**REQUEST**

Proposed Zoning: O-1(CD) LLWPA, AIR (office, conditional, Lower Lake Wylie Protected Area, Airport Noise Overlay)

The petition proposes to allow the construction of two hotels on a vacant piece of land previously developed with a single family home.

Staff recommends approval of this petition upon resolution of outstanding issues related to environment, and site and building design.

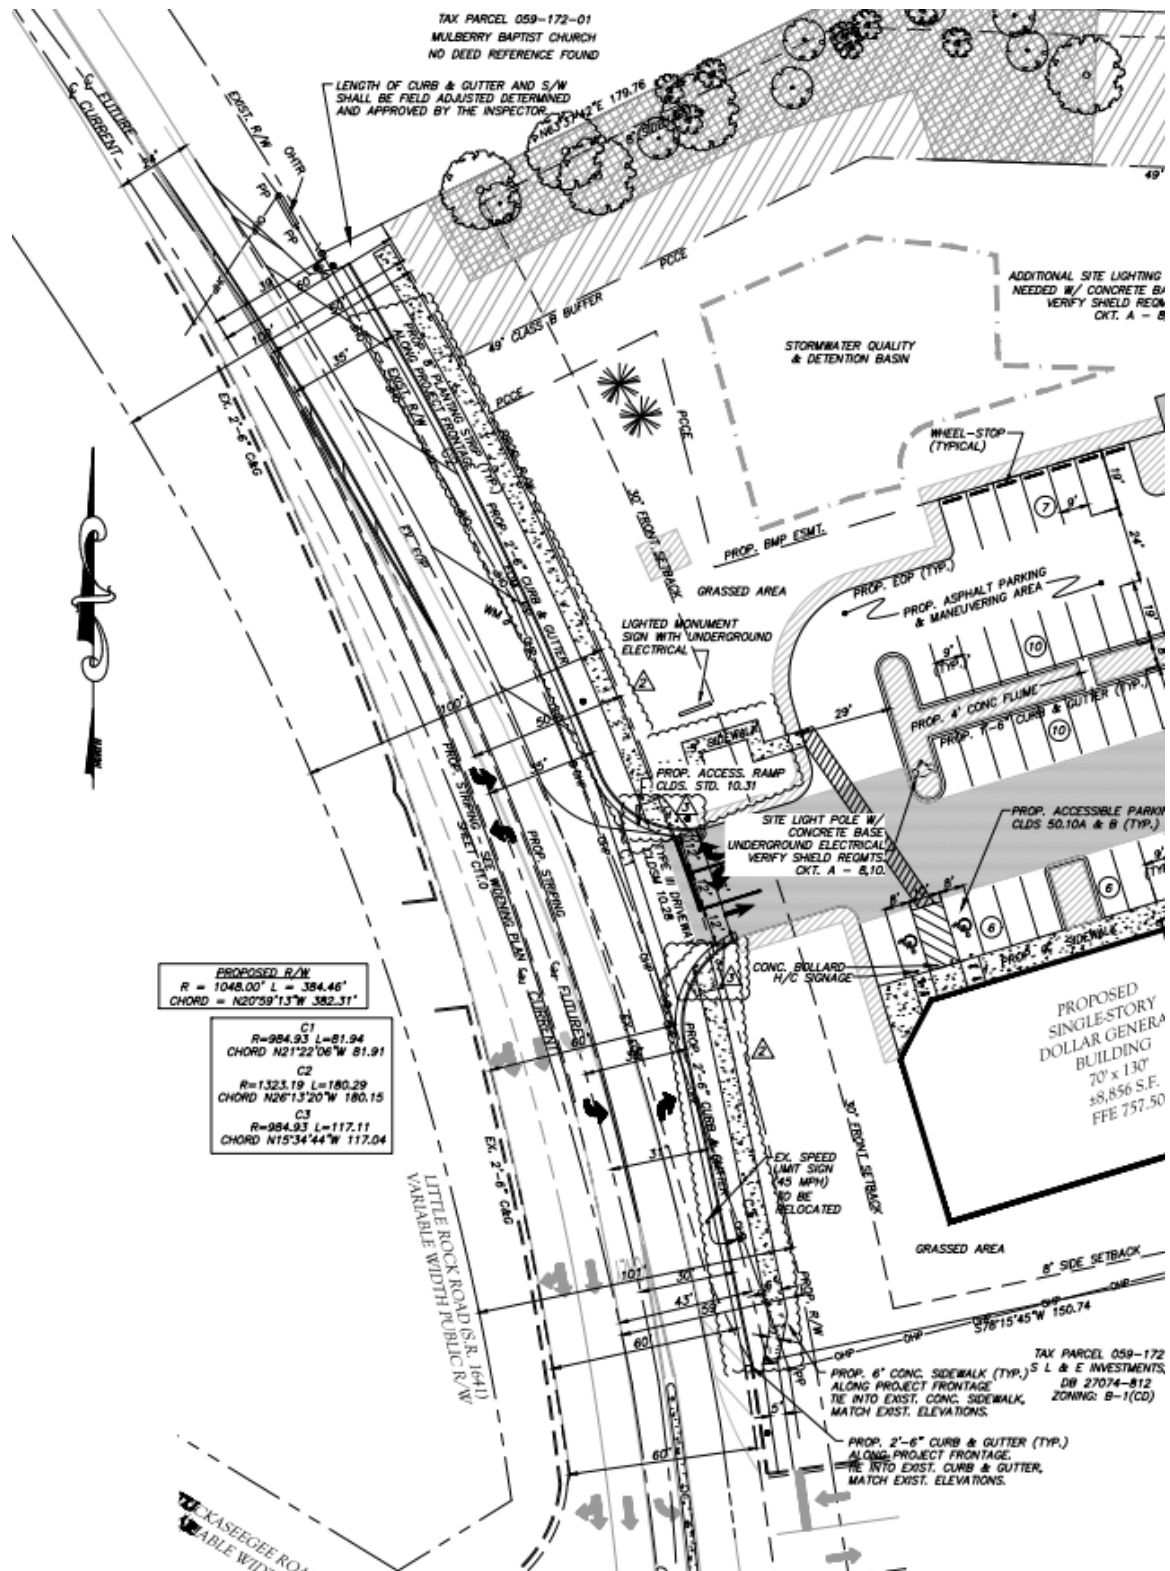
6. Show tree save calculations clearly in table on site map. Not Addressed. Petitioner has responded that this is a construction document required, not a rezoning standard.

7. Add the following notes: Placement and Site Design shall focus on and enhance the pedestrian environment on public or private network required streets, through the following:

- Buildings shall be placed so as to present a front or side façade to all streets.
  - Facades fronting streets shall include a combination of windows and operable doors for a minimum of 40% of each frontage elevation transparent glass between 2 feet and 10 feet on the first floor. Up to 20% of this requirement may be comprised of display windows. These display windows must maintain a minimum of 3'-0" clear depth between window and rear wall. Windows within this zone shall not be screened by film, decals, and other opaque material, glazing finishes or window treatments. The maximum sill height for required transparency shall not exceed 4'-0" above adjacent street sidewalk.

- The facades of first/ground floor of the buildings along streets shall incorporate a minimum of 30% masonry materials such as brick or stone.
  - Direct pedestrian connection should be provided between street facing doors, corner entrance features to sidewalks on adjacent streets.

- Building elevations shall not have expanses of blank walls greater than 20 feet in all directions and architectural features such as but to limited to banding, medallions or design features or materials will be provided to avoid a sterile, unarticulated blank treatment of such walls

- Building elevations shall be designed with vertical bays or articulated architectural features which shall include a combination of at least three of the following: a combination of exterior wall offsets (projections and recesses), columns, pilasters, change in materials or colors, awnings, arcades, or other architectural elements.

- Buildings should be a minimum height of 22 feet.
  - Building elevations above ground floor should have a minimum transparency of 20% per floor.

The petitioner has responded that many, if not most of these requested changes are appropriate for retail uses but not for hotel uses. Petitioner has included a number of additional architectural conditions consistent with hotel design and the building placement on the site. Petitioner has provided the following language:

*The development of the site will be governed by the district regulations of the Zoning Ordinance for the O-1 district. The first floor of the building elevations will be designed to encourage and complement pedestrian activity by providing windows and/or doors and other architecturally articulated facades that prevent expanses of solid walls that exceed 20 feet in length. Direct pedestrian connections will be provided from main entrances to sidewalks on adjacent streets as generally depicted on the site plan. The height of the buildings will be limited to 3 stories. Buildings that do not present either a front or side toward a public street shall have four sided architecture with the same level of architectural treatment and interest as the entry side of the building. Building elevations will be designed with vertical bays or articulated architectural features which shall include a combination of at least three of the following: a combination of exterior wall offsets (projections and recesses), columns, pilasters, change in materials or colors, awnings, arcades, or other architectural elements.*
